## COMMITTEE OF ADJUSTMENT

# **NOTICE OF PUBLIC HEARING**

## **Application for Consent/Land Severance**

**APPLICATION NUMBER:** FL/B-21:43

TPD-1

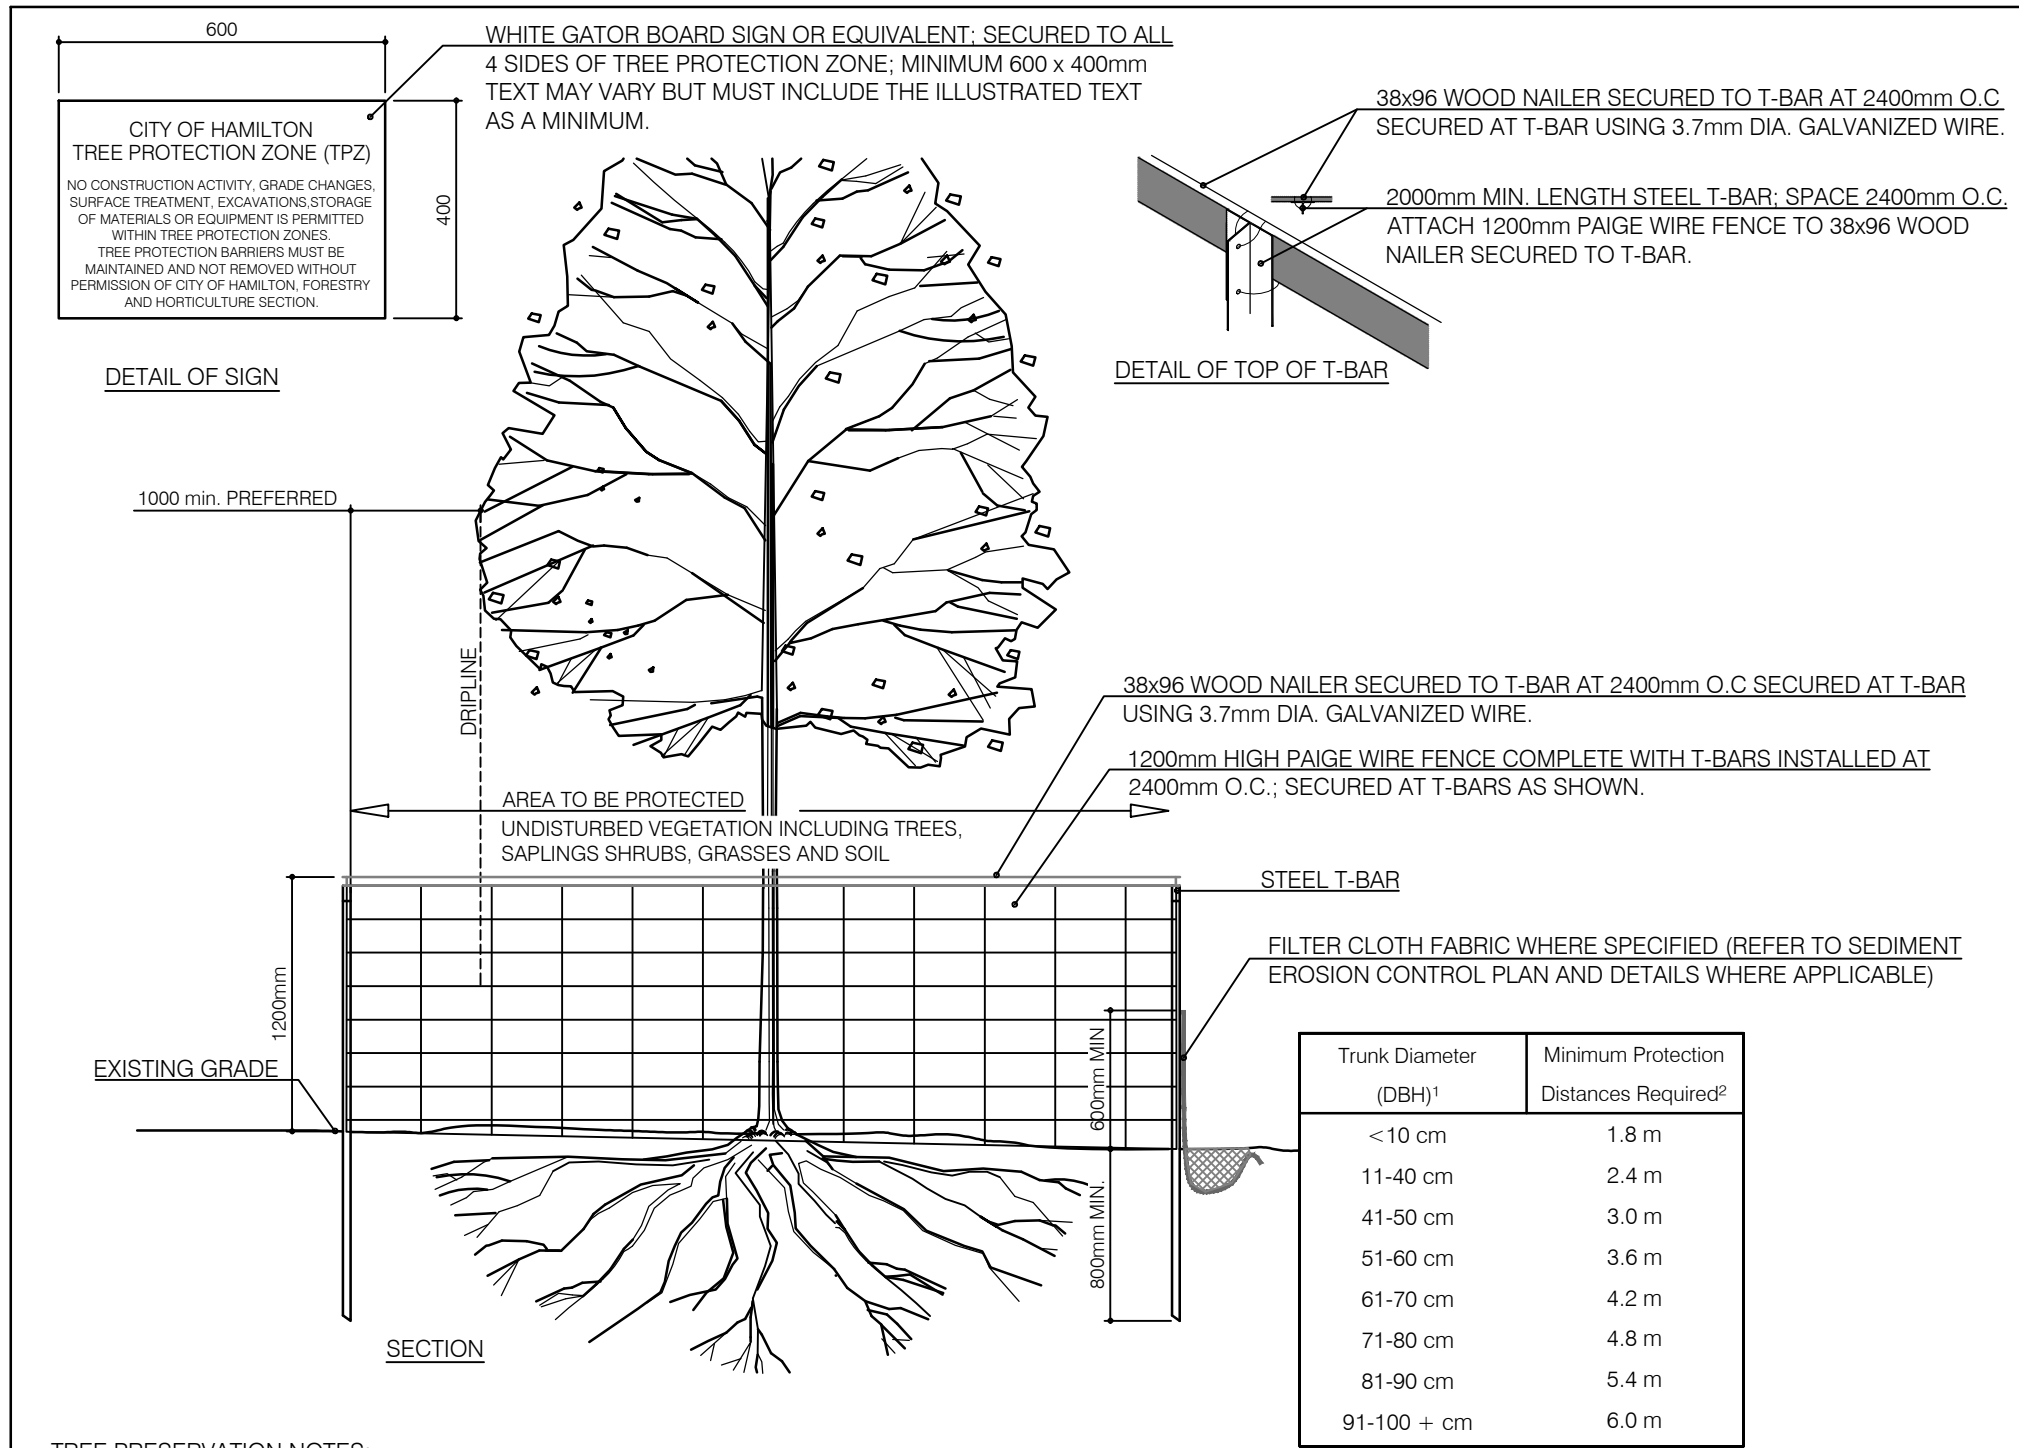
4. The applicant shall submit and receive approval for a Tree Protection Plan, to the satisfaction of the Manager, Development Planning Heritage & Design.

Before the severance and minor variances are approved, a Tree Protection Plan is recommended. The City should have some indication of the potential impacts to trees (on and off site) before it approves the severance.

To support this resubmission and address comments from stakeholders regarding potential tree impacts from the proposal, we have prepared a Tree Impact Study which includes a Tree Identification Table has been prepared and submitted. This Study includes conceptual dwelling footprint sizes and shapes on both Proposed Lot 1 and Proposed Lot 2. The intent is to show maximum dwelling footprints, based on a 25% maximum lot coverage, within the potential building envelopes created by the permitted dwelling setbacks. It also includes potential driveway widths and locations.

minimize tree impacts and removals. The plan provides potential tree protection fencing locations to show how areas of construction and disturbance can be limited within each site. Further, it confirms that existing trees that would need to be removed based on this concept are located solely on the subject lands. In our opinion, this adequately address comments from the Committee and stakeholders, and confirms that tree impacts are a minor and manageable issue. It also underscores that the proposal will main compatibility with the character of the neighbourhood by retaining most of the existing trees. For instance, based on this plan and these assumptions, approximately 76% of existing trees will be retained on site.

We note that the previous staff comments requested the submission of a Tree Protection Plan as a condition of approval. Given we have addressed this issue with our Tree Impact Study submission, we respectfully request that there be no conditions requiring further Tree Protection Plan submissions attached to the decision.

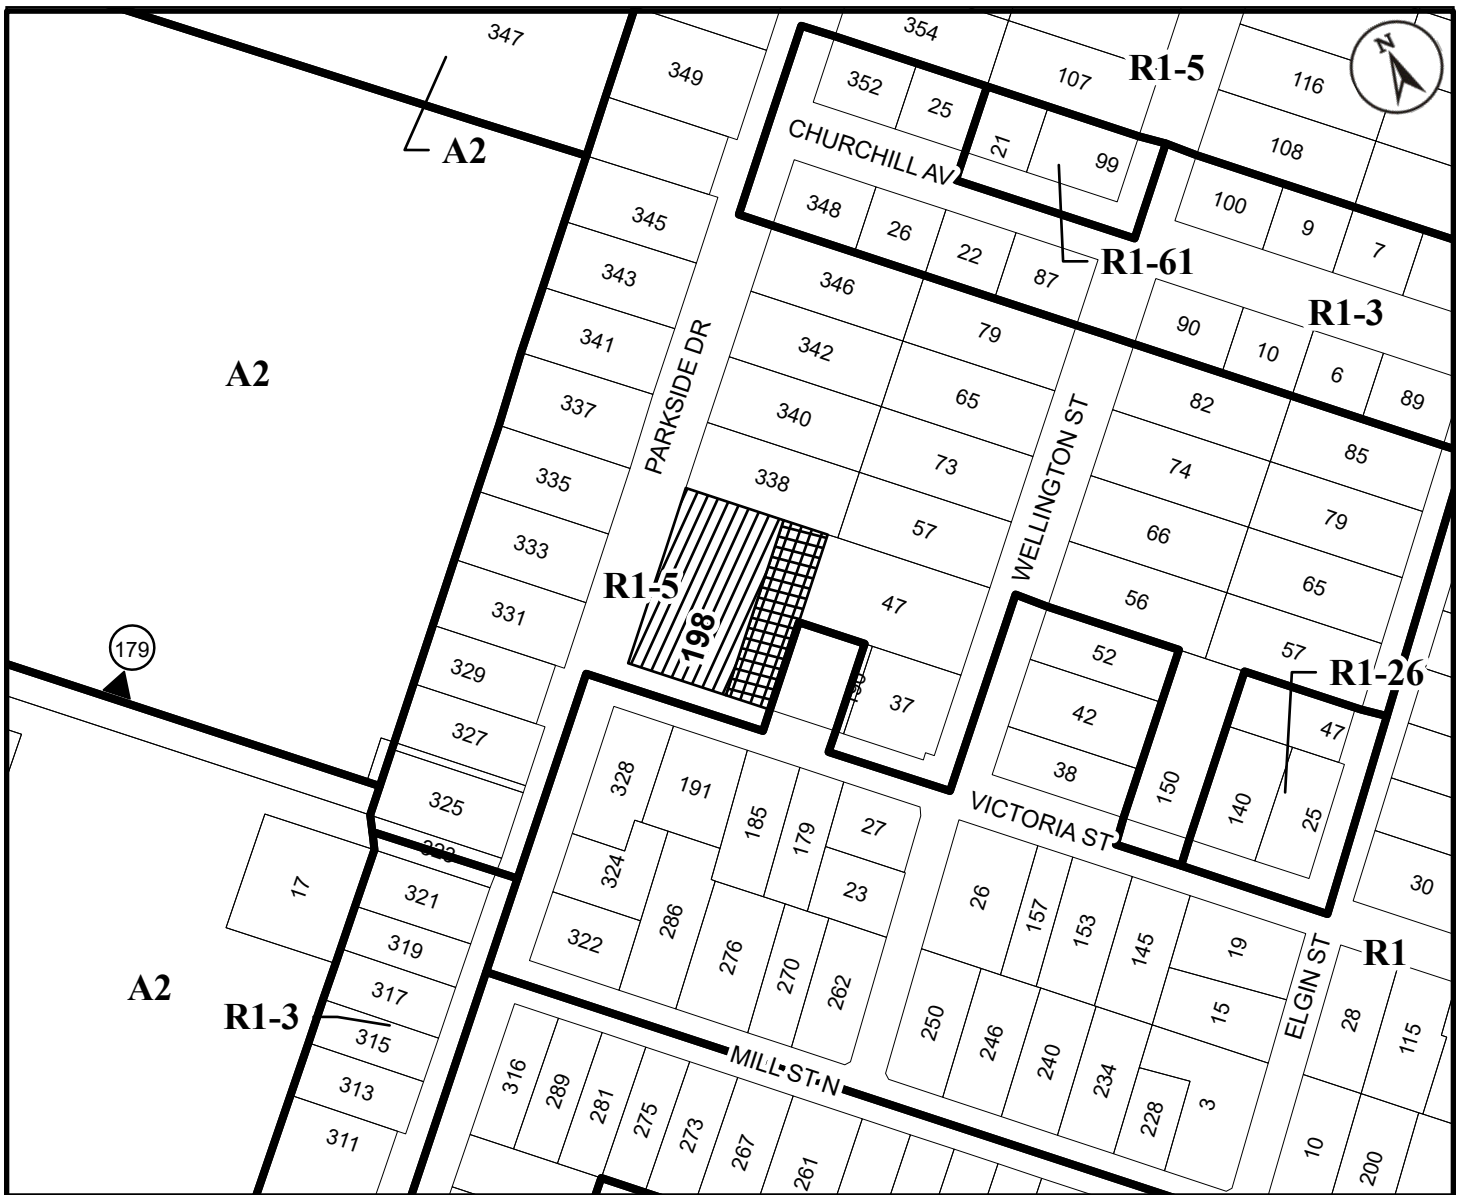
There are currently six variances between the two applications being requested, all of which are related to the small size of the proposed lots. In the case of Lot 3 the proposed dwelling is 1.2 meters from our fence. In a neighbourhood that has 9+ meters between houses it is preposterous to propose a house that sits so close to the property line.

In addition to the small lots proposed, the developer has clearly no interest in saving the mature trees or greenery on the property. There are many trees, 50+ years old, that will be removed to make way for these houses. If people wish to purchase a new house with a small property and no trees they can go purchase one of the 5000+ homes they are building on Highway 5.
